# P802.3bt D3.0 – Dual-signature LLDP v151

This is an overhaul for the LLDP specification in Clause 79, specifically addressing dual-signature operation. It aims to address the issues raised in comments #130, #293, #294, #296, and #297.

Figure 145–39—PSE power control state diagram for single-signature PDs

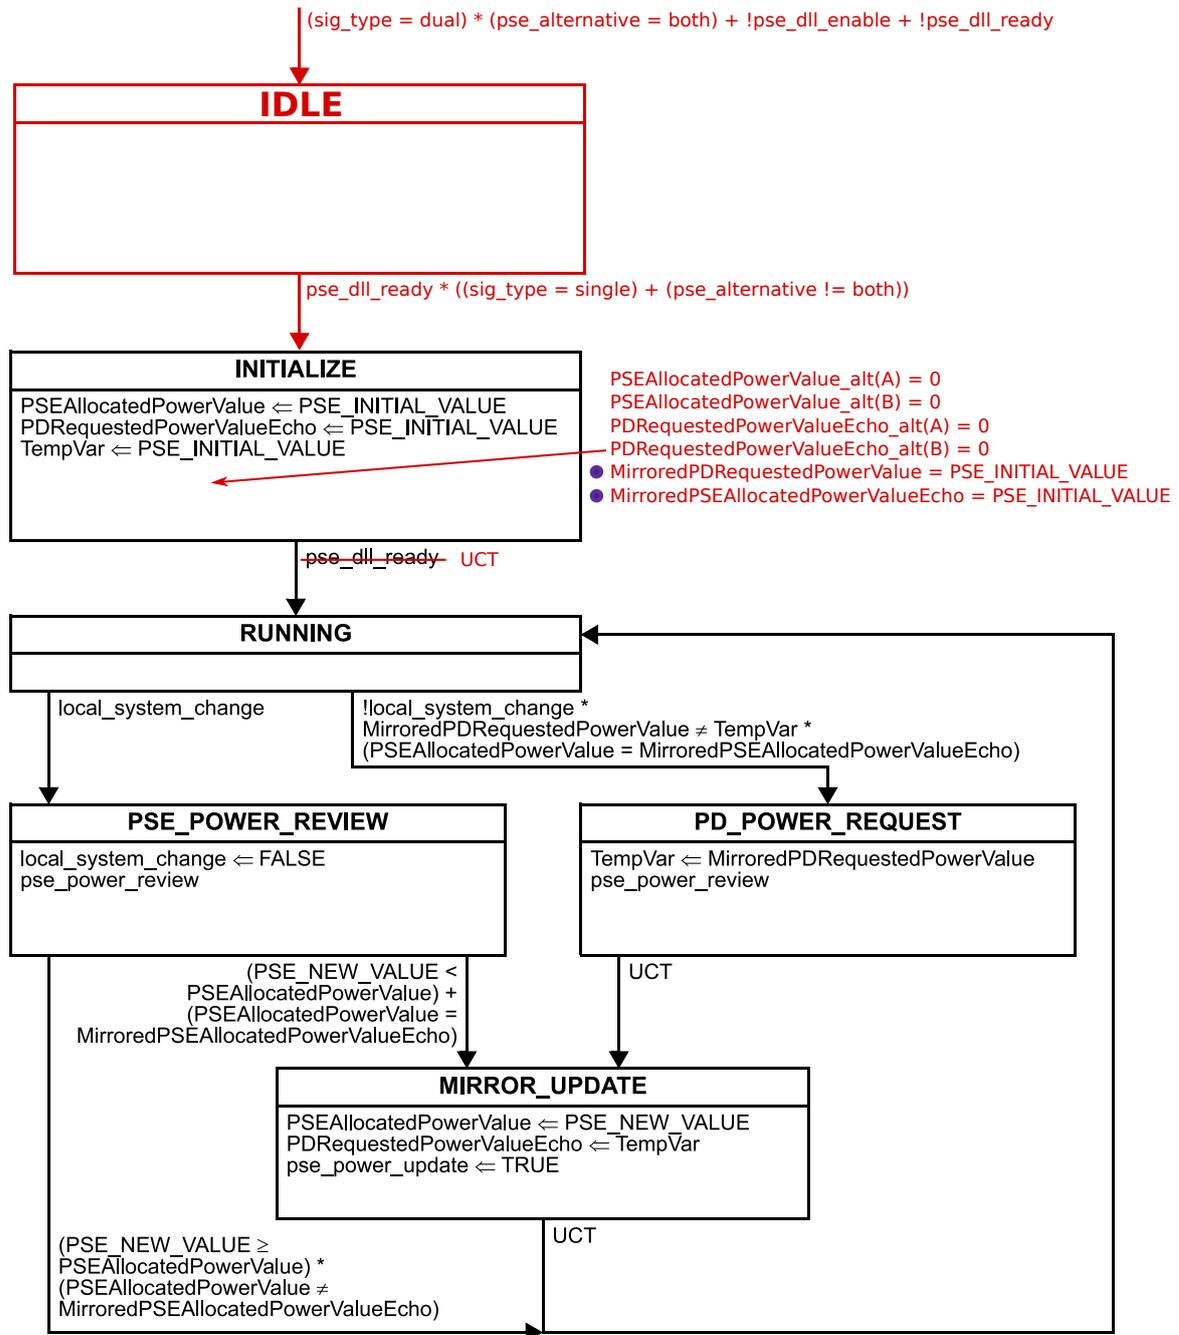
This is one of the three state diagrams that the PSE needs to run. It sits in IDLE whenever DLL isn't enabled or not ready, or when the other state diagrams need to be in control (dual-signature detected). It proceeds to INITIALIZE when DLL is ready and the PD is a single-signature, or the PSE is restricted to 2-pair operation.

Also fixed is the issue where Mirrored\_\* variables are read before they are set. Mirrored variables contain the contents of incoming LLDPDUs and get set only when a frame is received. During the time between the first frame being received and DLL being enabled, their value is undefined. Fixes related to this issue are marked with a purple circle.

Change Figure 145–39 as follows:

Figure 145–41—Single-signature PD power control state diagram

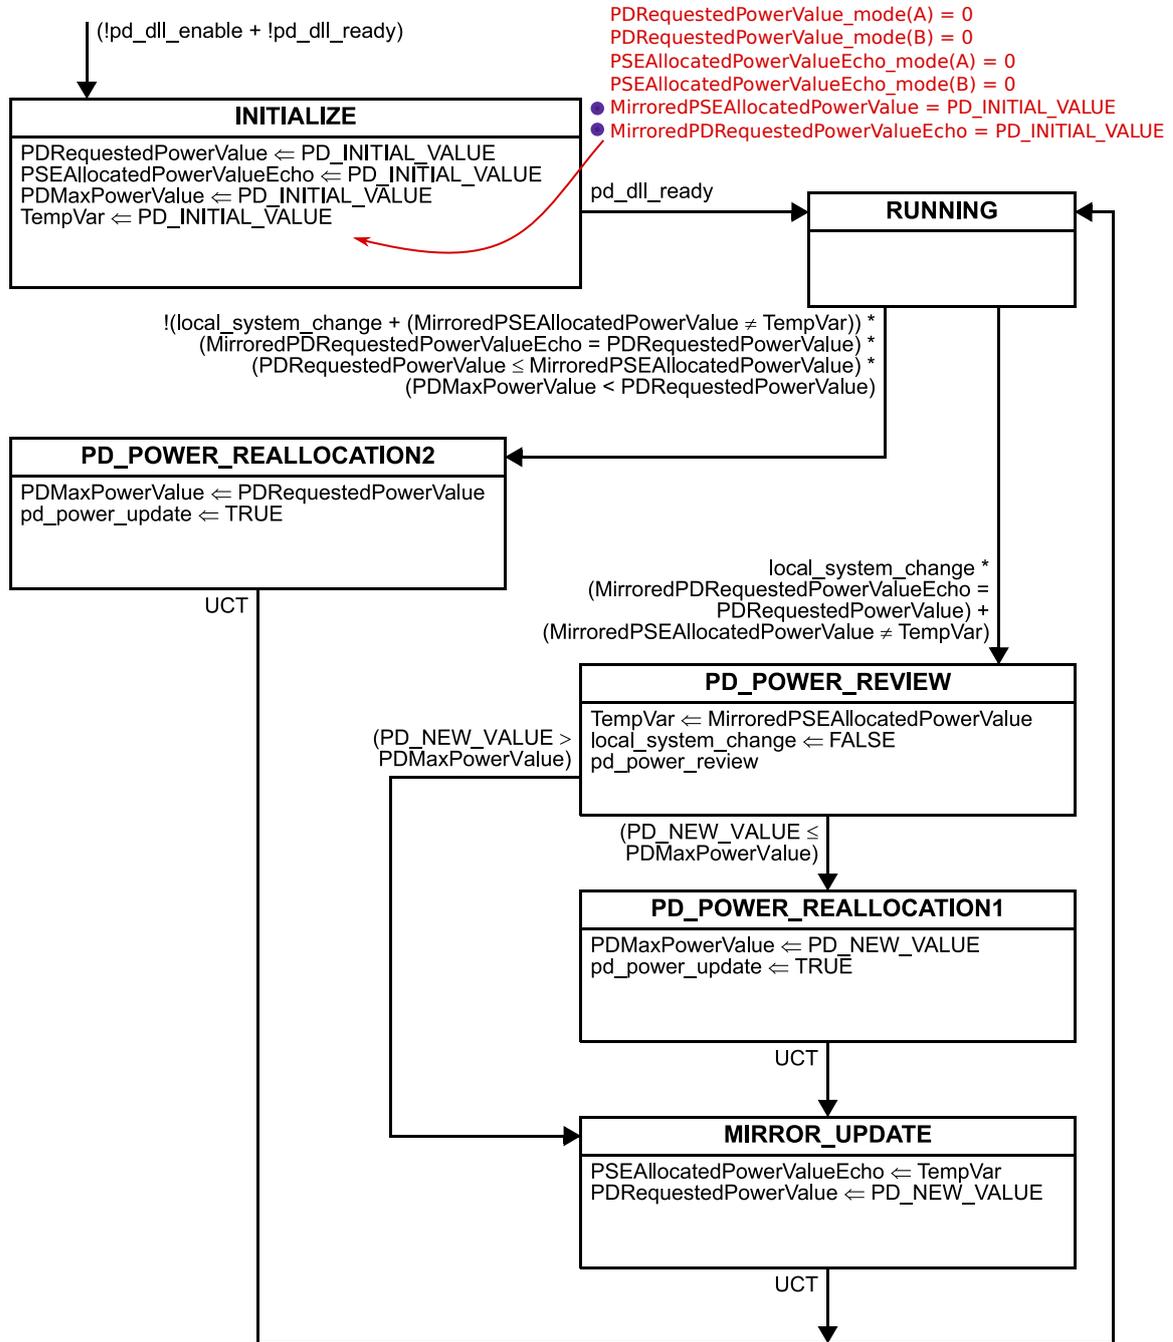
This is the state diagram for single-signature PDs. By setting the A/B fields to zero in INITIALIZE we have made this state diagram self-sufficient for single-signature. The other state diagrams intended for dual-signature do not need to run (as reflected in the text earlier).

Change Figure 145–41 as follows:

Figure 145–43—PSE power control state diagram for dual-signature PDs in 4-pair mode

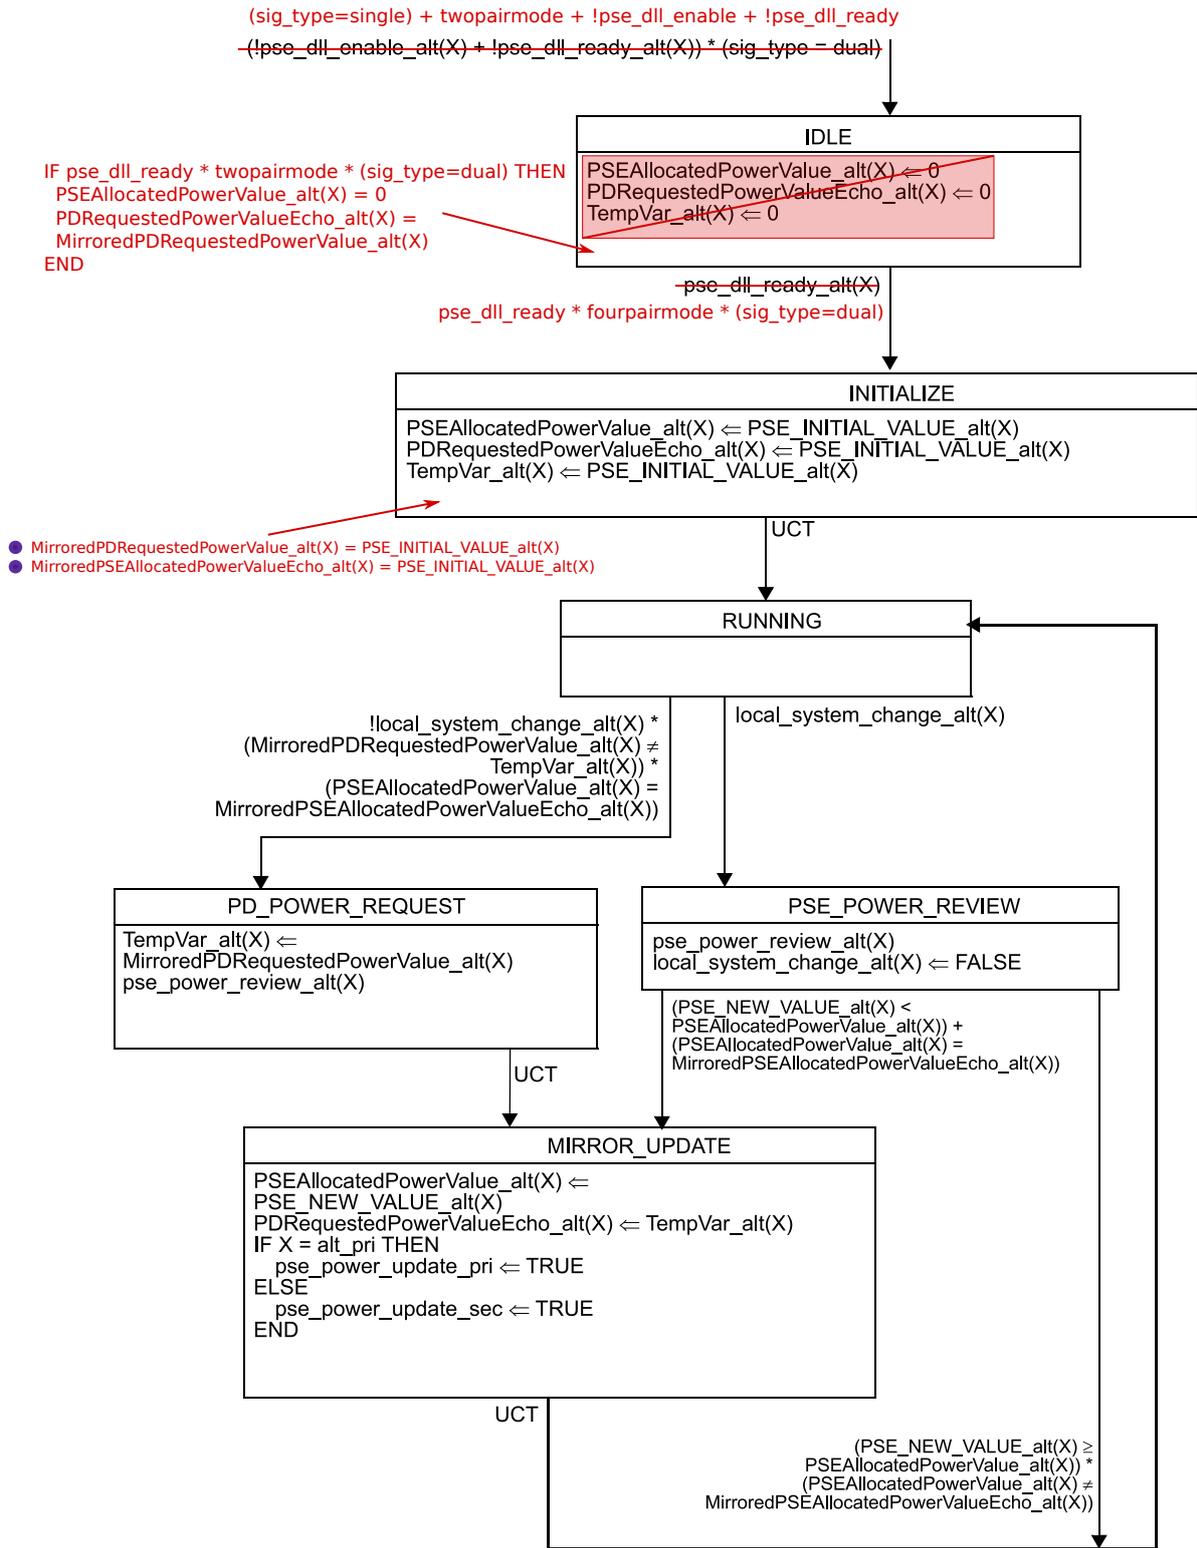
Change Figure 145–43 as follows:

Figure 145–43a—PSE power control state diagram for dual-signature PDs in 2-pair mode

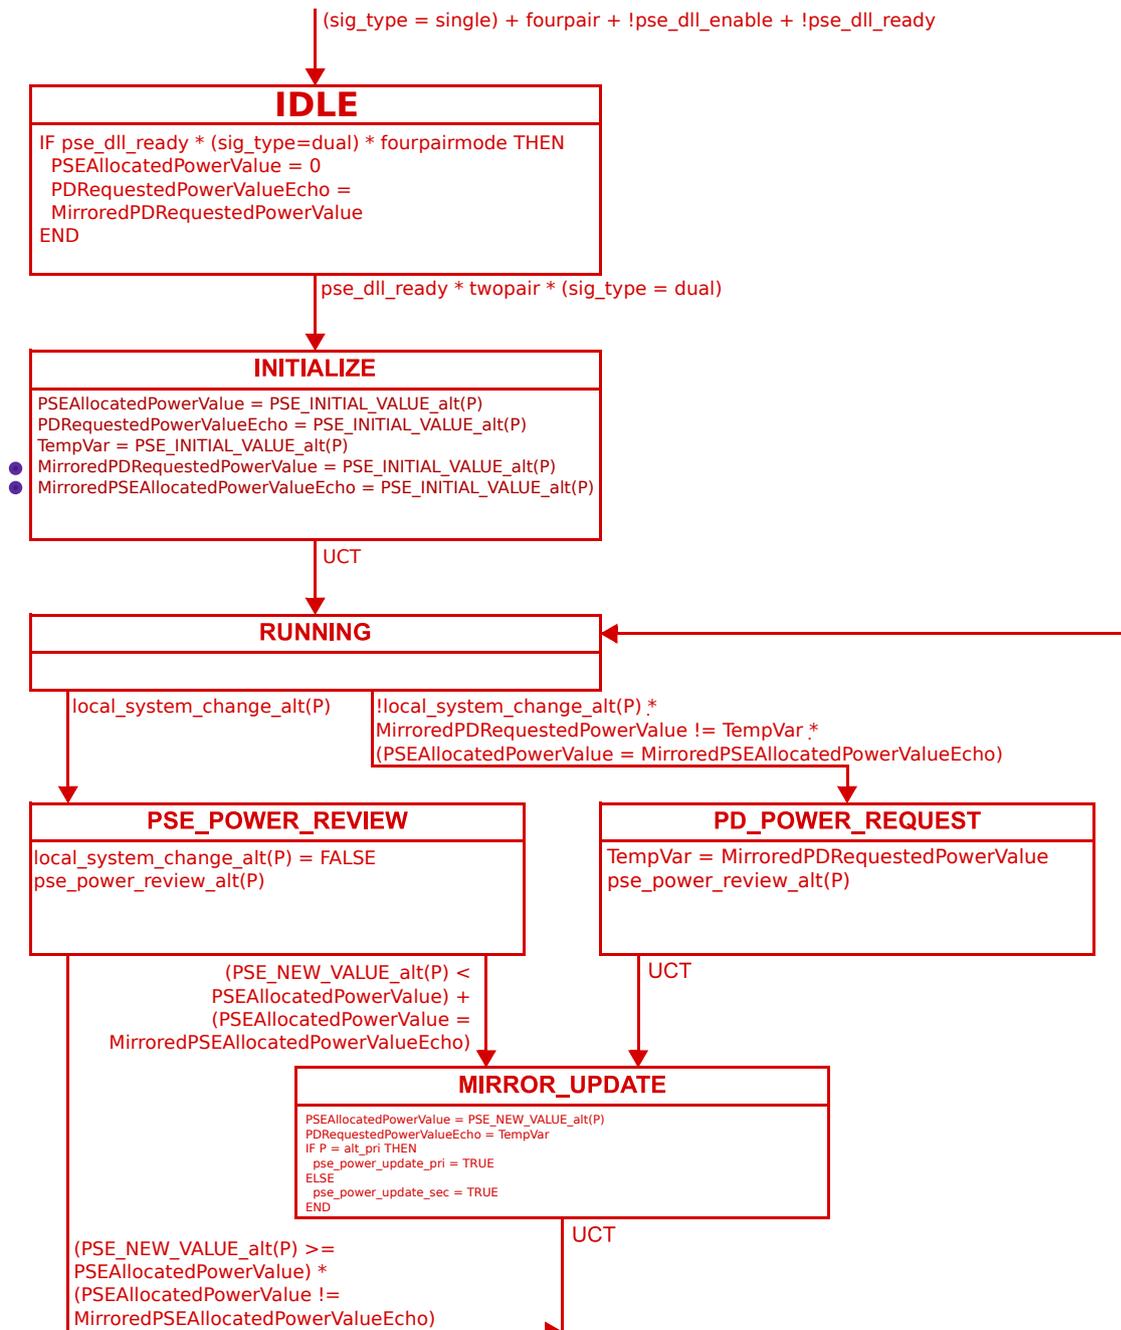
Insert Figure 145–43a as follows:
